SER24-044 Rev B
9/9/2024

SUBJECT: X4 7300/7500 SV4 Tube Assembly/Coolant Tube Contact

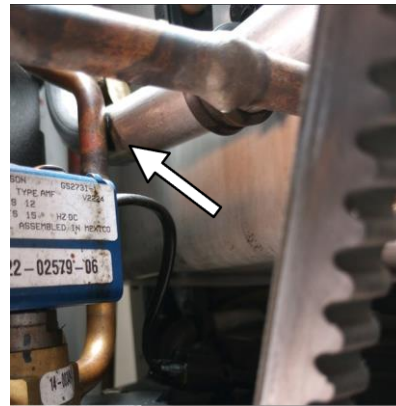
Certain X4 trailer refrigeration units (VAN91741971 to VAP91749838) may require the SV4 tube assembly to be inspected and adjusted to ensure no contact exists between the engine coolant tube and SV4 tube assembly. In limited cases, the SV4 tube assembly may require repair. See images below.
